Addendum to IFB

IFB NUMBER: IFB 24-064/MR
IFB TITLE: Popeye Holmes Park Concrete Walkway Renovation
IFB DUE BY: 11:00 am CT, Wednesday, November 13, 2024
ADDENDUM NO.: 2
ISSUED (DATE): November 7, 2024

1. Revised Bid Form is on page 3 of this addendum. The unit of measure and quantity of line items 1, 2 & 3 have been revised.
2. Revised Project Plans for sheet 5 (Quantity Summary), sheet 6 (Existing Plan) and sheet 7 (Proposed Plans) have been updated. These revised sheets are on pages 4-6 of this addendum,
3. The specifications for the pavers referenced are on page 7 of this addendum.

POPEYE HOLMES PARK
CONCRETE WALKWAY
RENOVATION
 JEFFERSON COUNTY PRECINCT NO.3

DESIGN	J.D.	SHEET 1 OF 1
CHECKED	M.F.	
QUANTITY SUMMARY		SHEET NO. 5

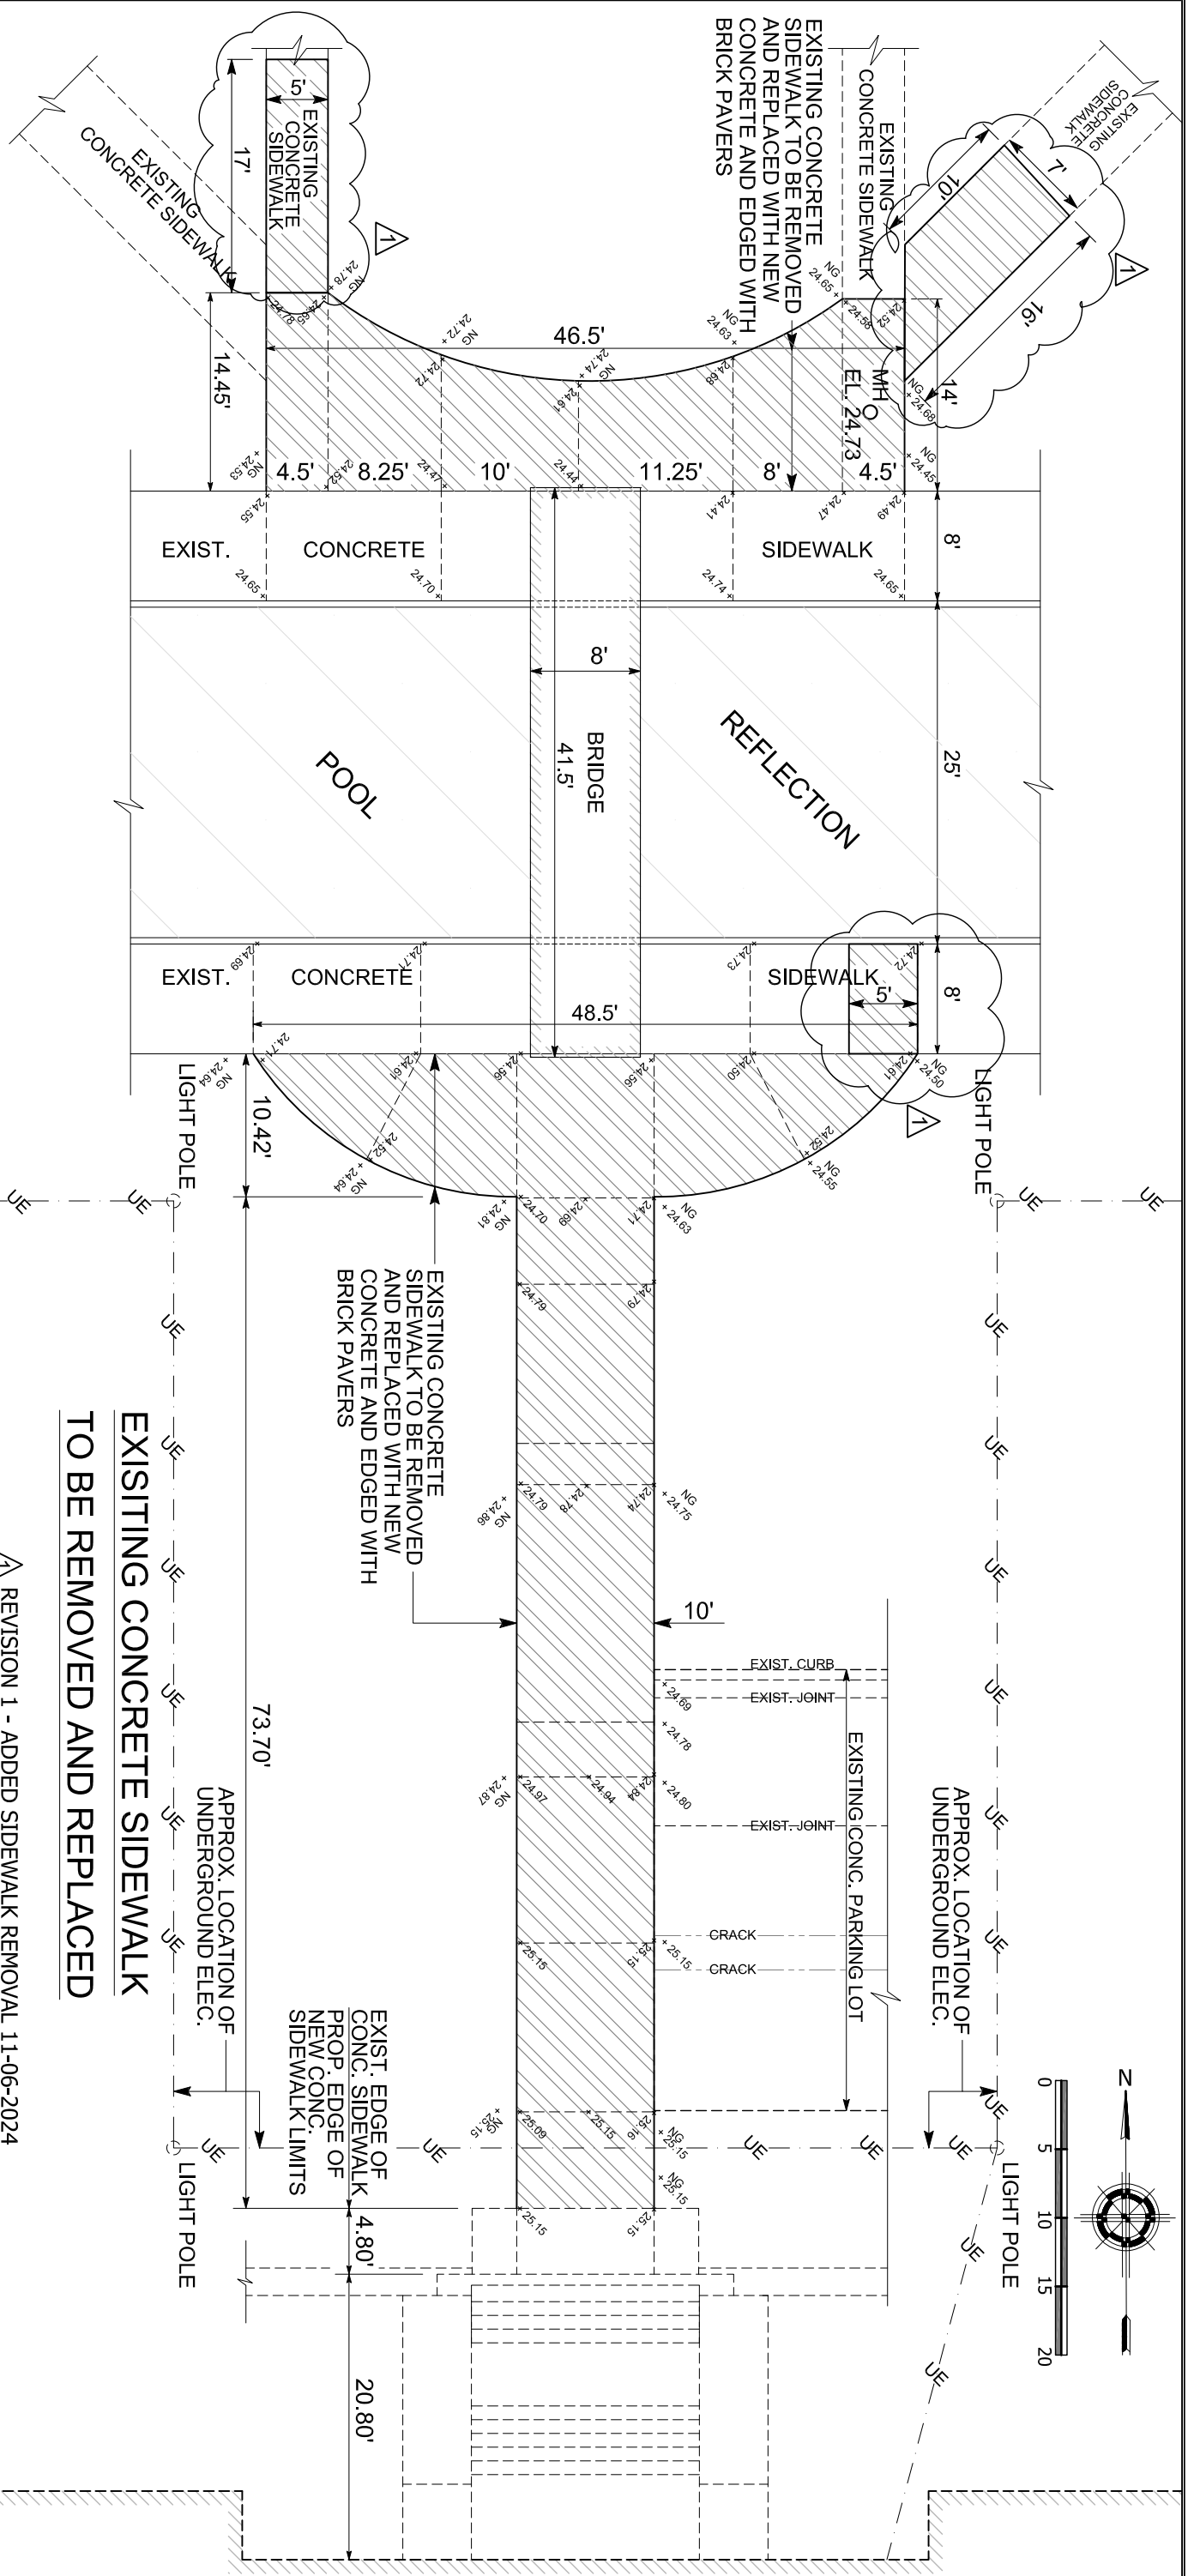
REV1 REVISION 1 - UPDATED QUANTITIES FOR ADDITIONAL PAVING AND CORRECTED UNITS FROM SY TO SF. 11-06-2024

JEFFERSON COUNTY	
POPEYE HOLMES PARK CONCRETE WALKWAY RENOVATION JEFFERSON COUNTY PRECINCT NO. 3	
DESIGN J.D. CHECKED M.F.	SHEET NO. 7 PROPOSED PLAN SHEET 1 OF 1

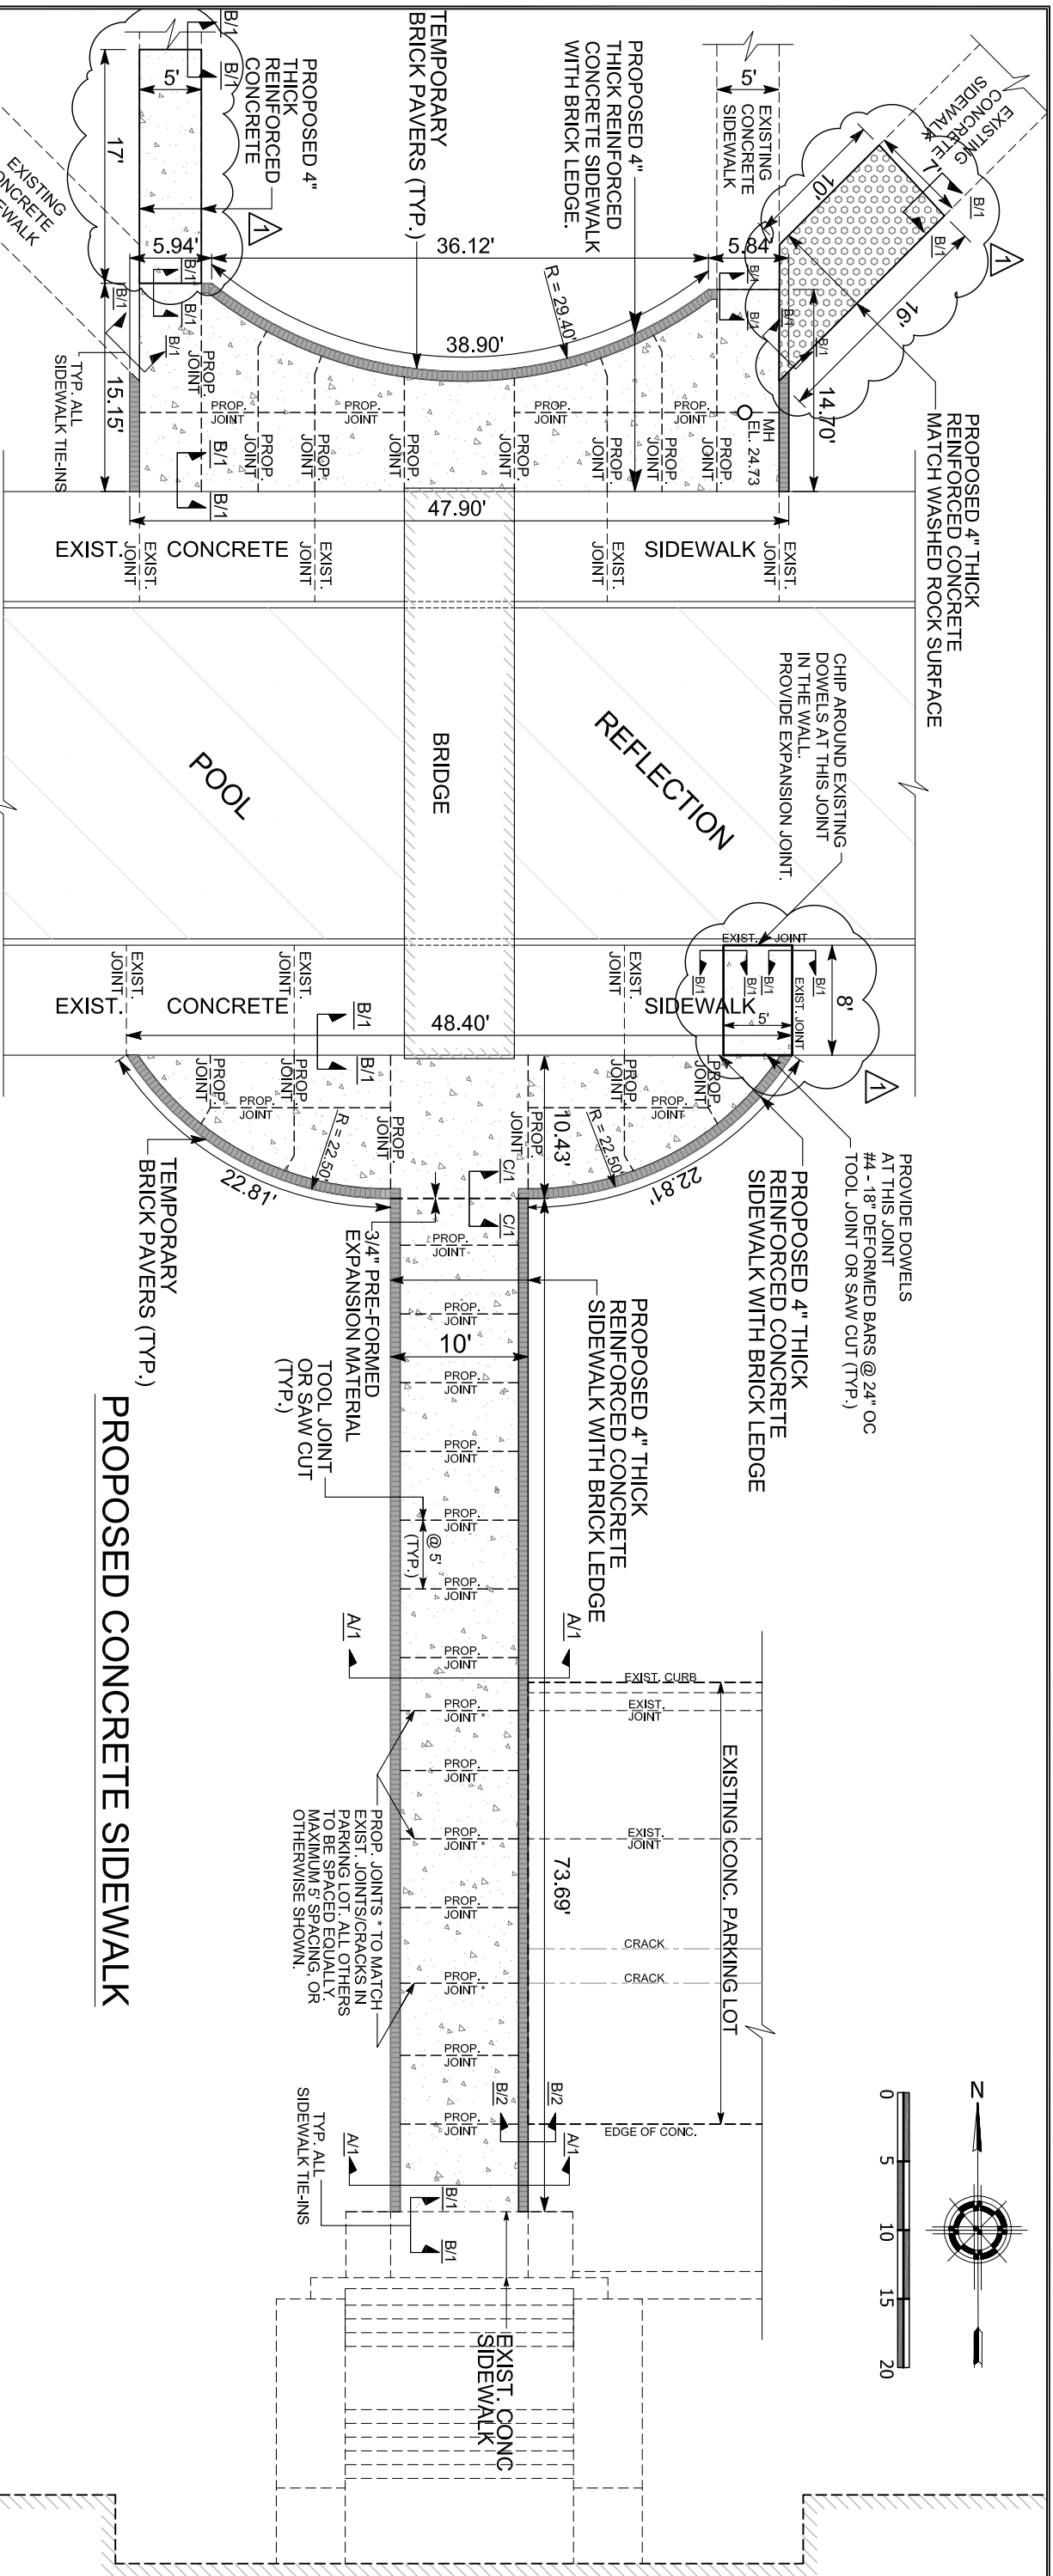
▲ REVISION 1 - ADDED SIDEWALK AND MODIFIED NOTES 11-06-2024

- NOTES:**
- 1) CONTRACTOR TO MATCH EXISTING SIDEWALK AND PARKING LOT GRADES WHEN TYING TO EXISTING SIDEWALK AND PARKING LOT.
 - 2) INSTALL TEMPORARY BRICK PAVERS PER MANUFACTURERS RECOMMENDATIONS.
 - 3) LIGHT BROOM FINISH FOR FINAL SURFACE TEXTURE. UNLESS OTHERWISE NOTED.
 - 4) DELETED
 - 5) JOINT LAYOUT TO BE VERIFIED WITH ENGINEER.

ISOMETRIC VIEW

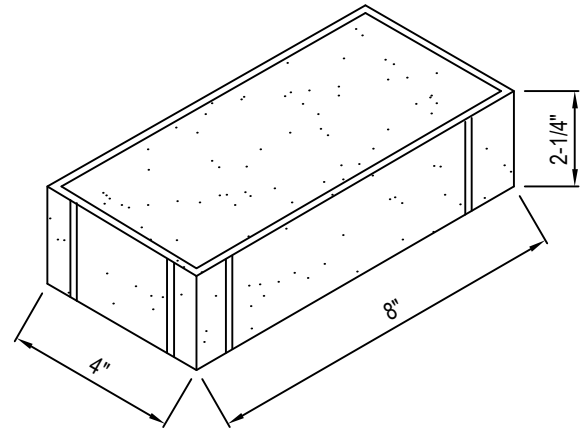
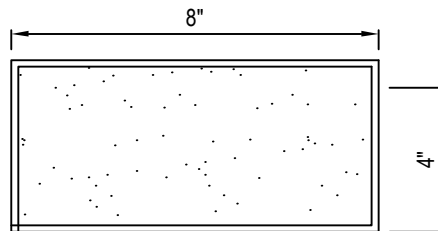
- WIRE CUT ← Brick Paver to be wire cut
- TUMBLED
